TECHNICAL MEMORANDUM

DATE November 24, 2021**Project No.** 21457143**TO** Sean Tylee
Port Colborne Quarries Inc.**CC** David Sisco**FROM** Luke Owens**EMAIL** Luke_Owens@golder.com**RESPONSE TO JART COMMENTS ON THE NATURAL ENVIRONMENT LEVEL 1 & 2 REPORT FOR THE PORT COLBORNE QUARRY EXTENSION****1.0 INTRODUCTION**

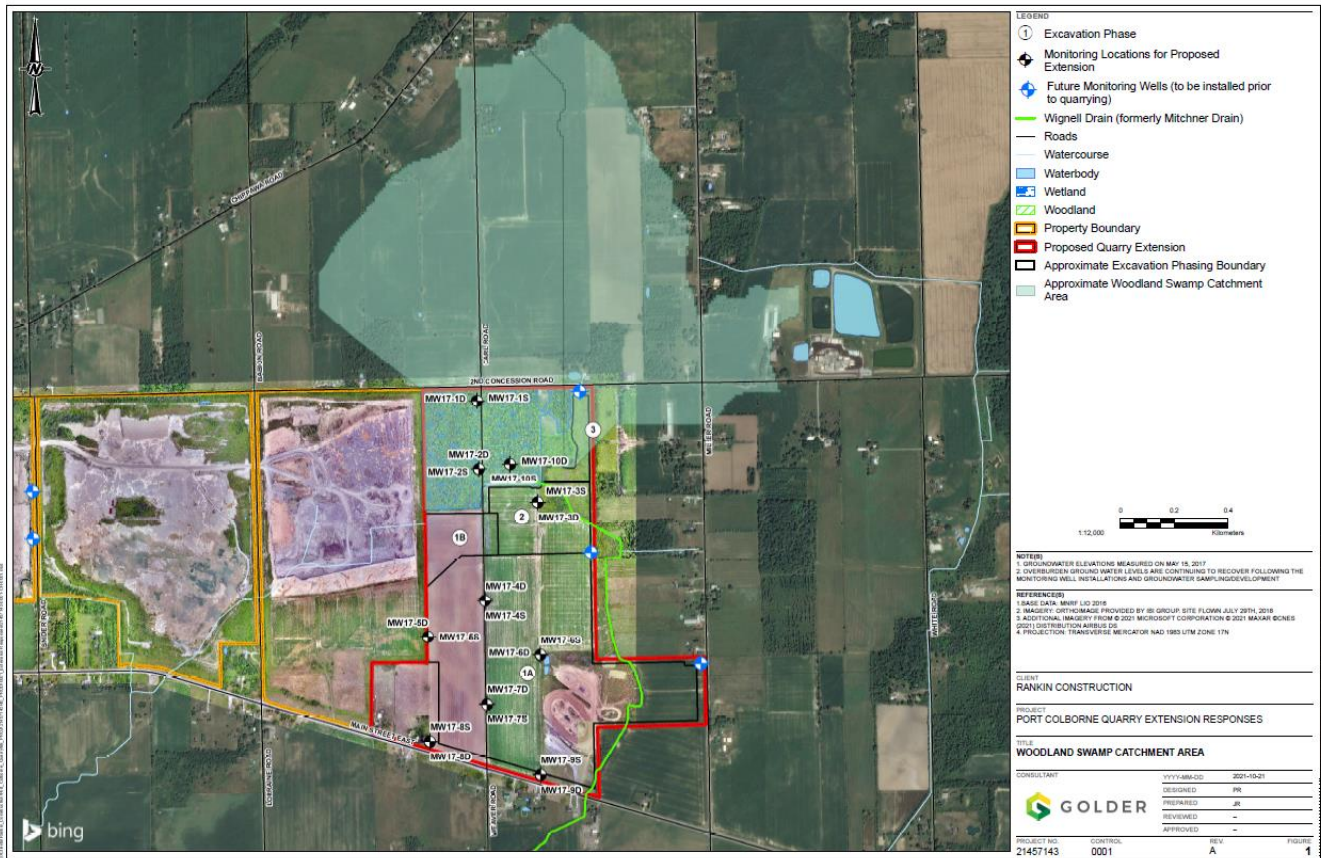
Comment 22.a: It is acknowledged that the hydrogeology and hydrology reports are referenced and indicate that no impacts to the hydrologic function of the swamp in the north area of the site are expected. With regard to the surface hydrology however, there are no maps presented that show the existing catchment and surface drainage patterns as they relate to the swamp; therefore, the no impact conclusion cannot be fully validated at this time.

Response 22.a: As shown in the figure below, the majority of the catchment contributing to the swamp is to the north, with only a small portion of the of the catchment being removed by Phase 3 of the expansion (<1% of the total swamp catchment). For this reason, impacts on the swamp caused by the loss of catchment area are not expected. Currently, the groundwater drawdown from the existing Pit 3 extends below the swamp area and has shown no significant impacts on the swamp water levels as a result of the impermeable nature of the soils. Therefore, the predicted extended drawdown as a result of the Pit 3 Expansion is not expected to have a significant impact on the swamp water levels.

PROJECT NO. 1771656 CONTROL 0017 REV. A FIGURE 3

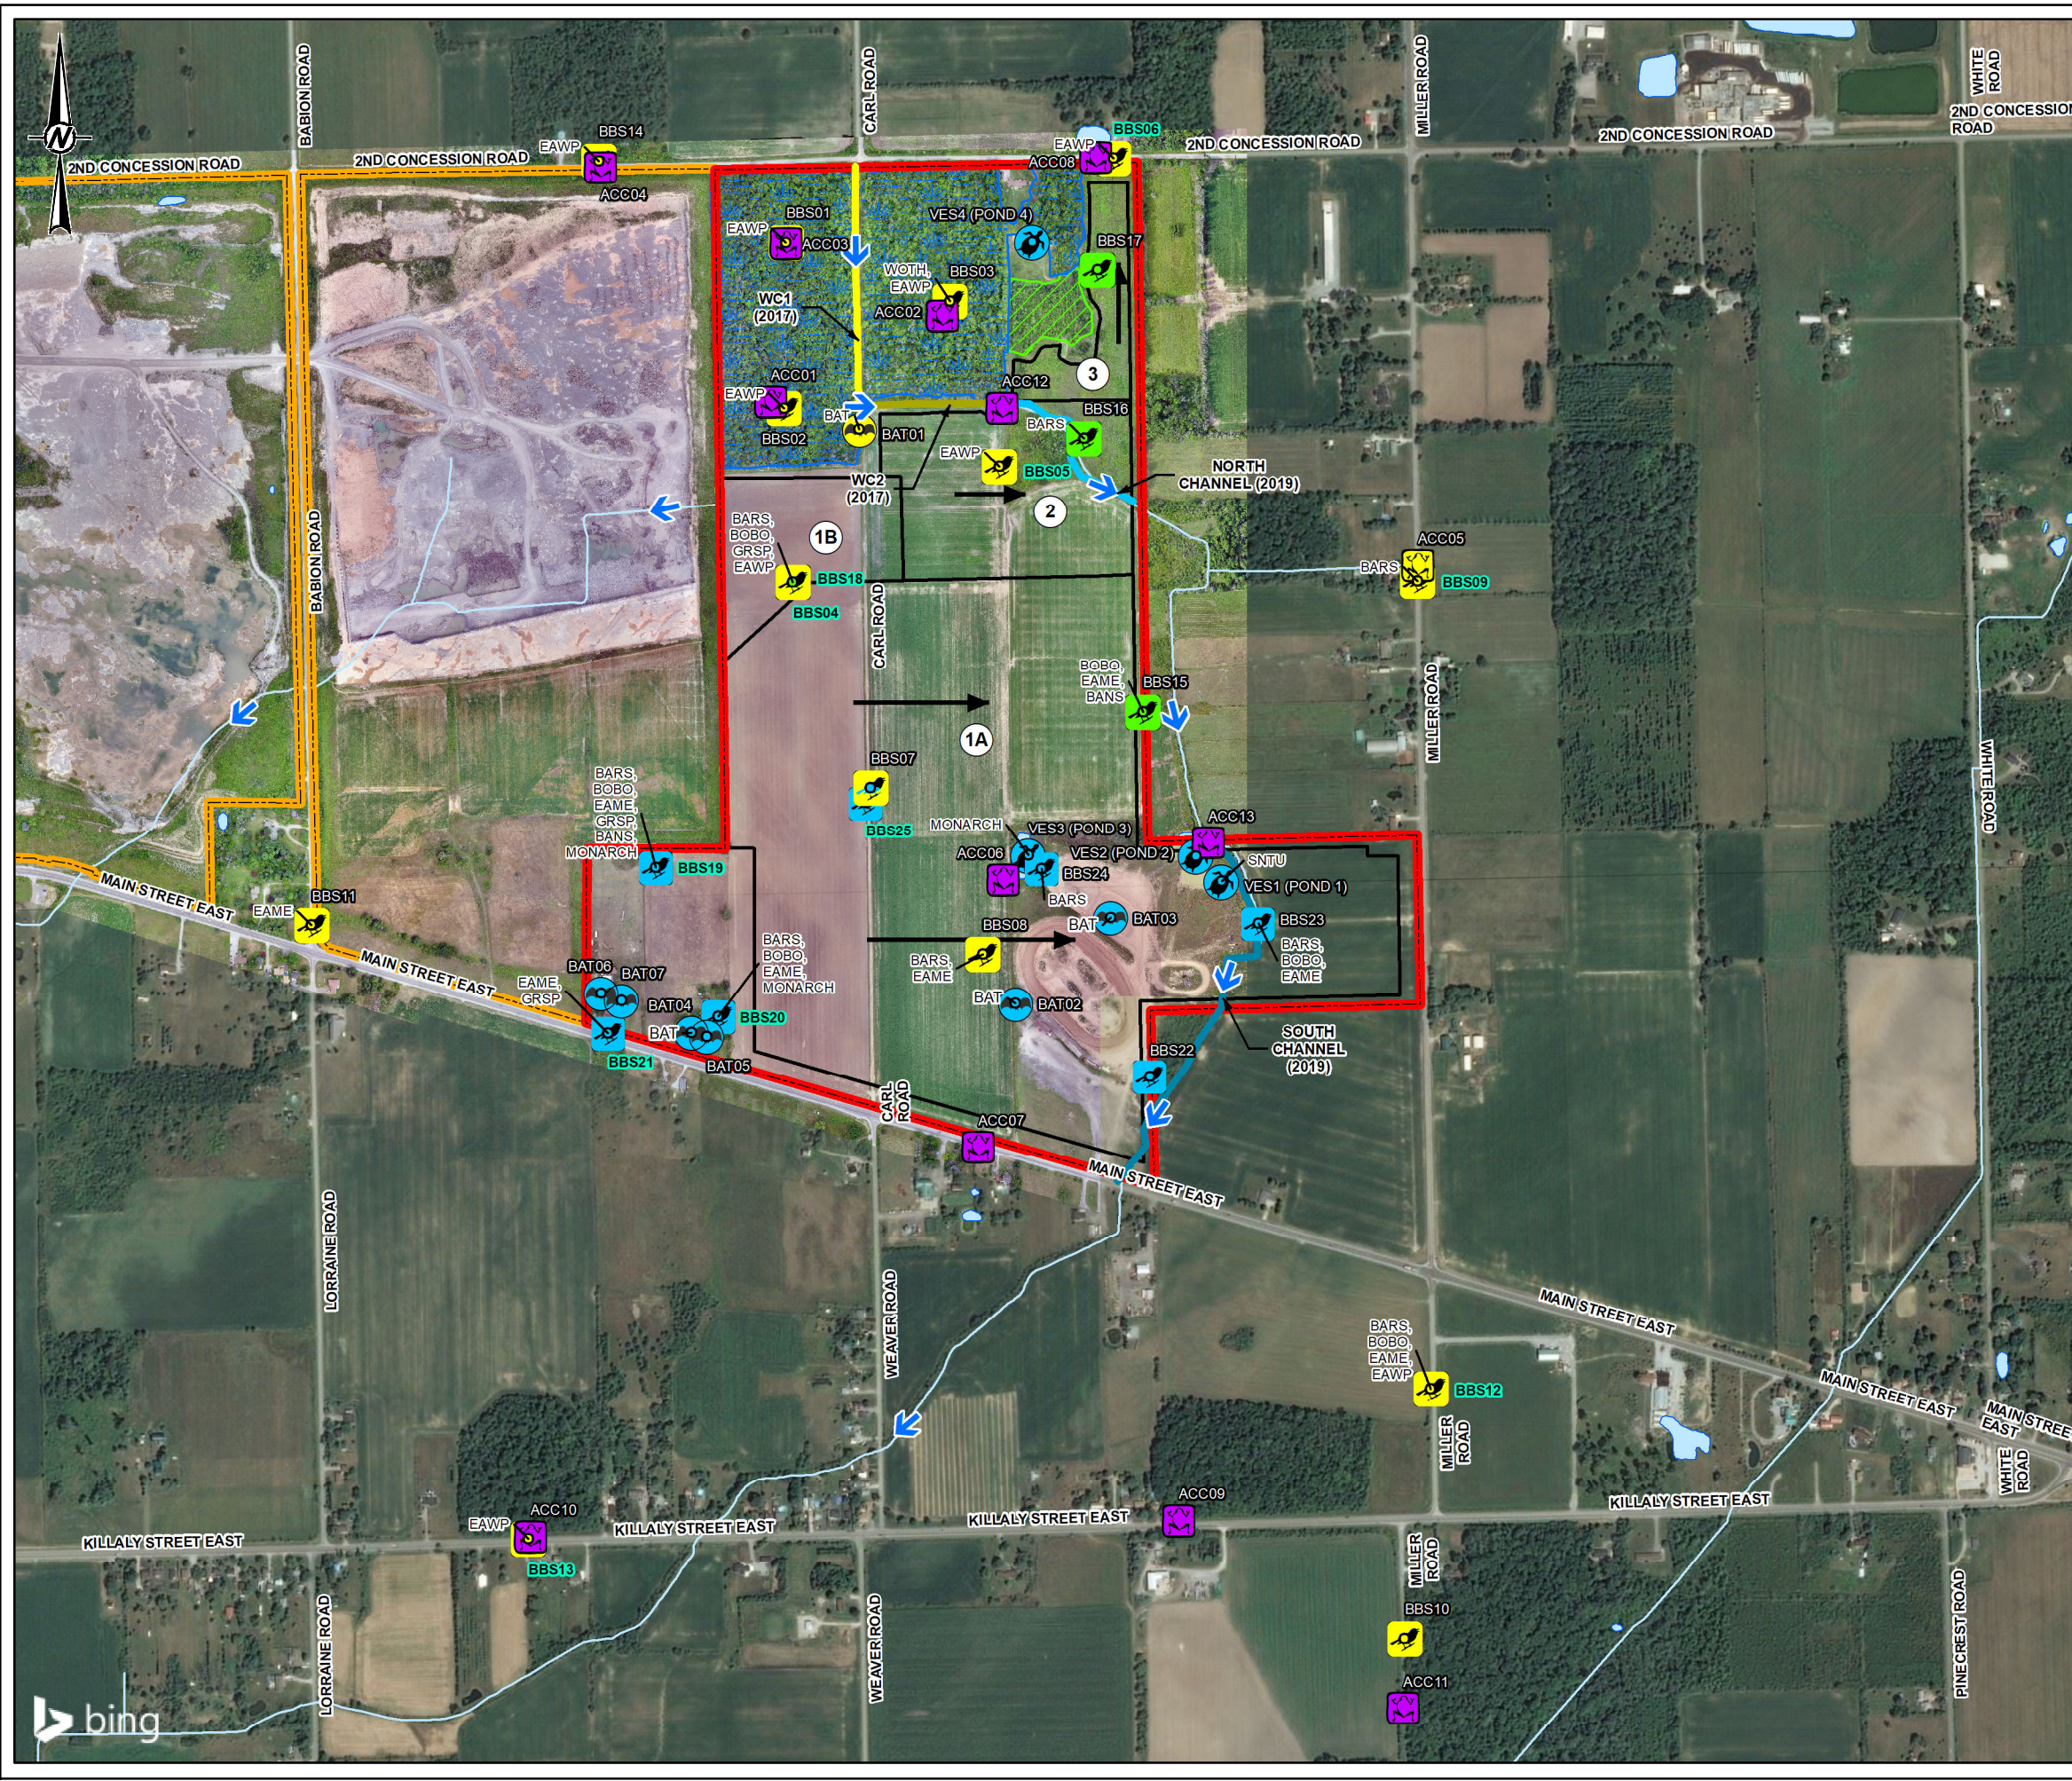
Comment 34.b: For clarity and future ease of review, please include Breeding Bird Survey (BBS) station 10 and Anuran Call Count (ACC) station 11 on Figure 3.

Response 34.b: Figure 3 has been updated to include BBS station 10 and ACC station 11 and is included with this technical memorandum.
